**GENERATION INTERCONNECTION
REQUEST # GI-2014-11**

**FACILITY STUDY REPORT
50 MW PV SOLAR, ALAMOSA COUNTY, COLORADO**

XCEL ENERGY – PSCO TRANSMISSION PLANNING WEST
August 9, 2016

B. Figure 3. Project General Arrangement at San Luis Valley Substation

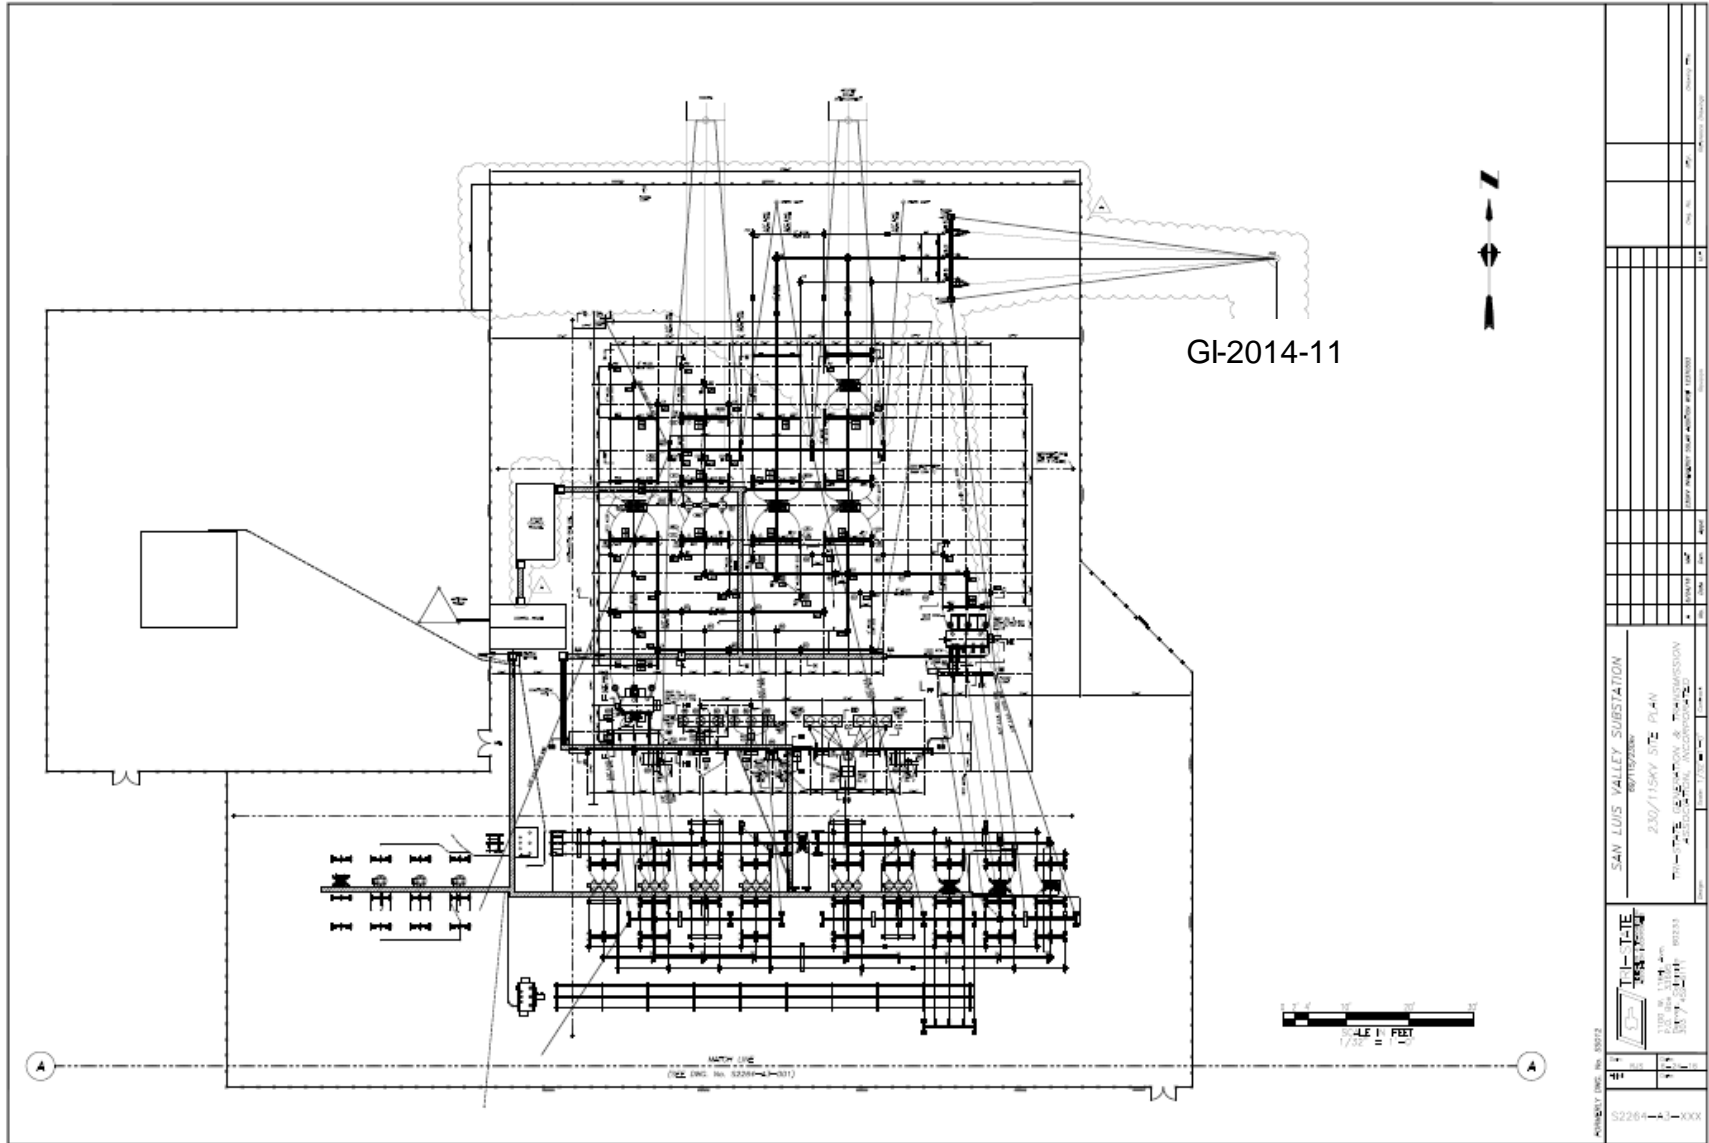
1. Please provide DC calculations to document/verify that the existing battery bank is insufficient and needs upgraded.
2. The existing control building has adequate space for one additional interconnection (either at 230kV or 115kV). Is a new building required at this time?
3. Tri-State would like to see a layout for the addition of the fifth 230kV breaker that sets up the station for a future breaker-and-a-half arrangement. We think this can be accomplished without too much effort. Please see the attached sketch provided by Steve Anderson, Tri-State's Substation Civil Engineering Manager. Thanks.

When putting together the facility study packages we were assuming that the separate RTU project would use the spare panel position in the existing EEE. Also based on Xcel Energy standards the interconnection would require two panels, one for breaker failure relaying and one for line relaying. These are the two items that prompted the need for the additional EEE.

B. Figure 3. Project General Arrangement at San Luis Valley Substation

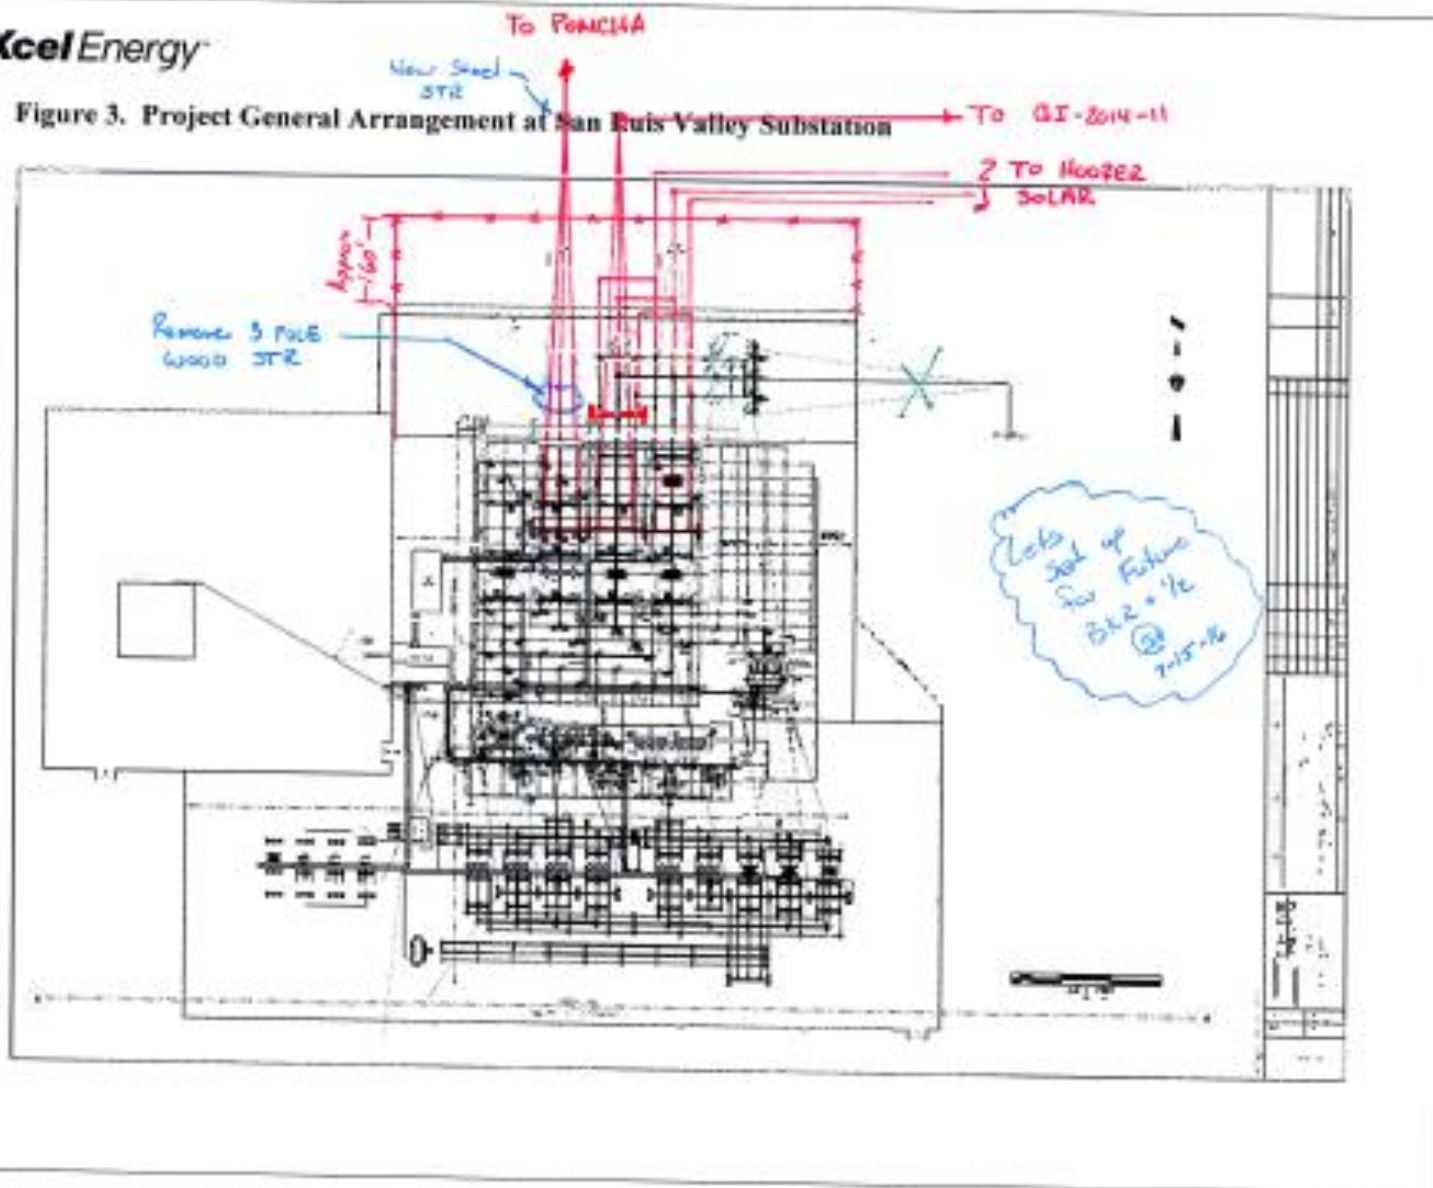
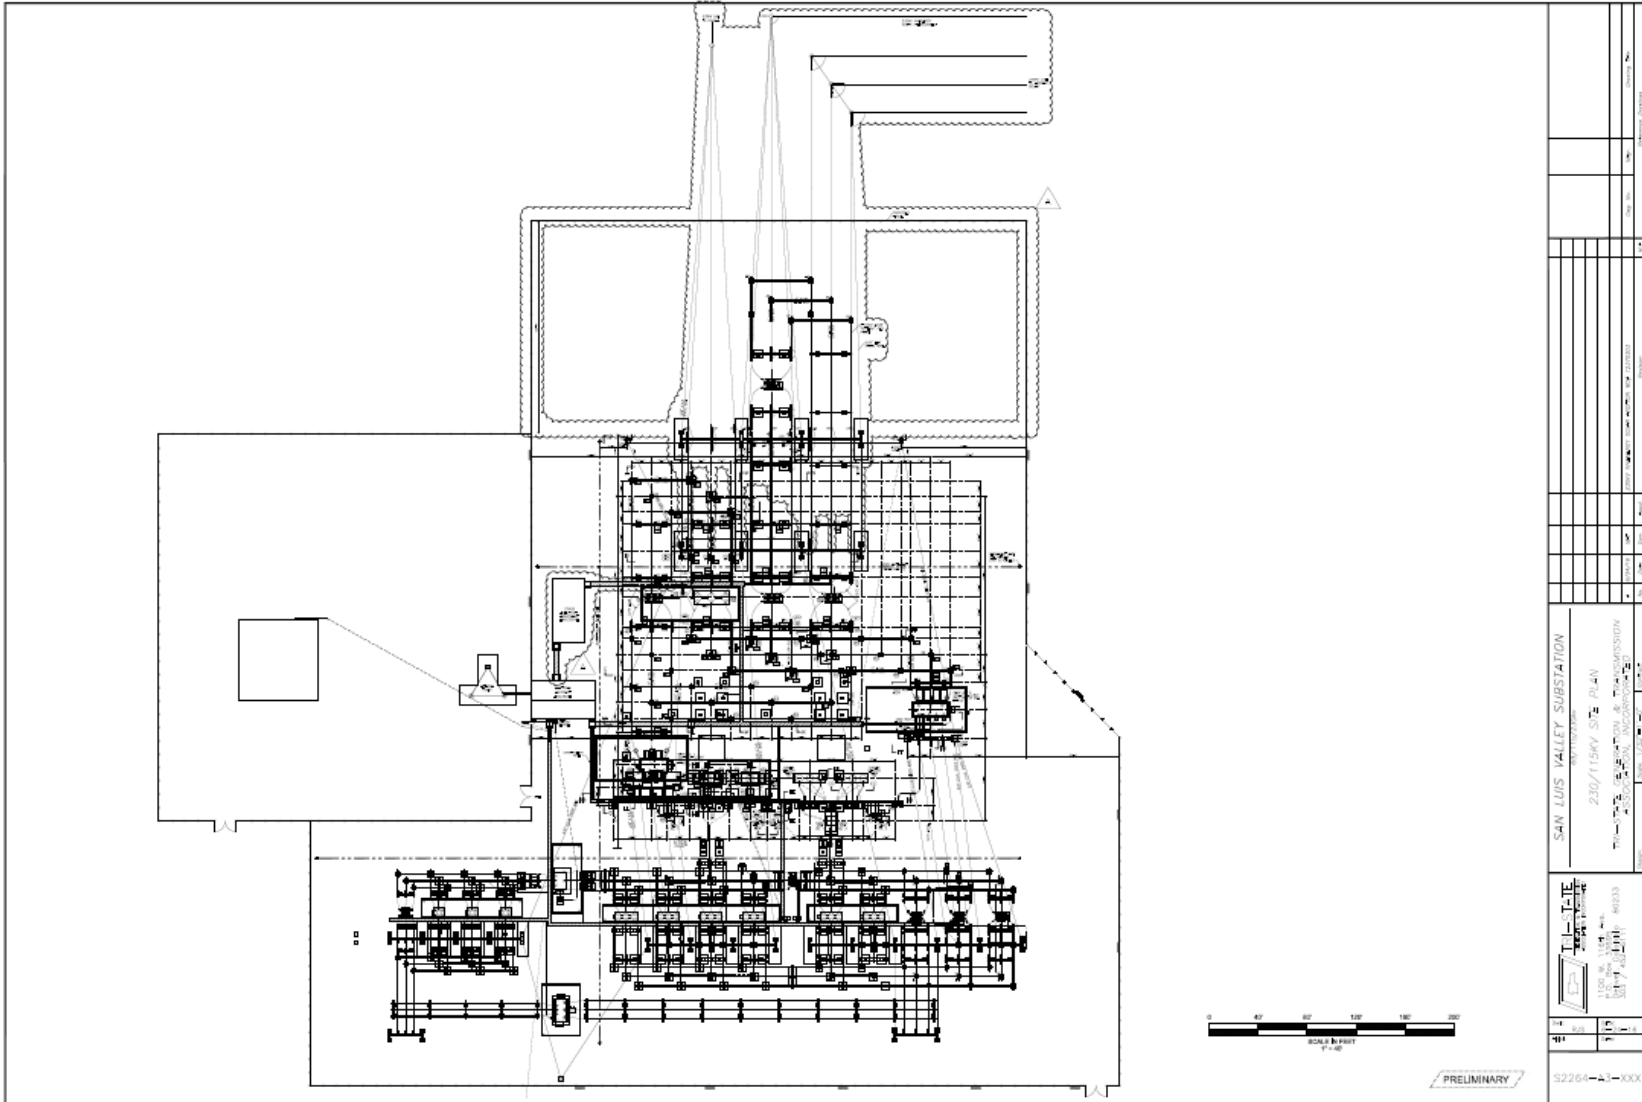
3. Tri-State would like to see a layout for the addition of the fifth 230kV breaker that sets up the station for a future breaker-and-a-half arrangement. We think this can be accomplished without too much effort. Please see the attached sketch provided by Steve Anderson, Tri-State's Substation Civil Engineering Manager. Thanks.

We are working on getting this arrangement drafted up per Steve's markup and will include in a follow up email as soon as it is complete.
